February 20, 2017

RE: Draft Environmental Impact Statement for the additional Growler Aircraft on Whidbey Island.

Re: Objection Pacific Northwest Electronic Warfare Range (EWR)  
More Specifically Re: The Draft Decision Notice and Finding of No Significant Impact (DN/FONSI) issued on November 29, 2016, by the Responsible Official, Dean Millet, the District Ranger of the Pacific Ranger District of the Olympic National Forest, which is the affected National Forest

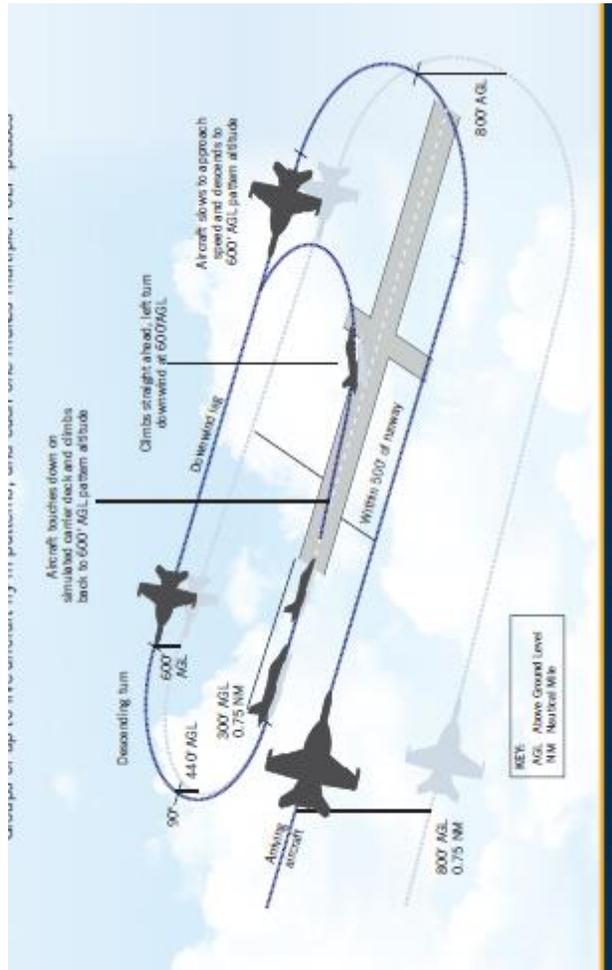
The geographic area proposed to be covered by the EIS is limited to the Whidbey Island area generally, and to landings, takeoffs, and touch and go training at Ault and OLF fields. In this regard, a diagram on the left side of the “Growler Operations” page of the Scoping Meeting Guide is most telling. That diagram includes three flight paths that extend to the southwest of the area shown as follows:

Those flight paths, we are sure, lead to the Navy’s proposed Pacific Northwest Electronic Warfare Range (EWR). The impacts of the Growlers on those flight paths do not end at the boundaries of the Navy’s diagram. The impacts extend as far as the Growlers fly.

Under NEPA those impacts must be evaluated in the EIS – both in the area between Whidbey Island and the proposed EWR, and in the area of the proposed EWR. Because that was not done in the Navy’s Environmental Assessment (EA) for the proposed EWR, it should be done now. This is also necessary under the 1988 Master Agreement between the Department of Defense and the US Department of Agriculture. That Master Agreement requires the Forest Service to study both the impacts of the proposed land-based training activities and the impacts of the proposed use of airspace if “directly associated with the land based training.”
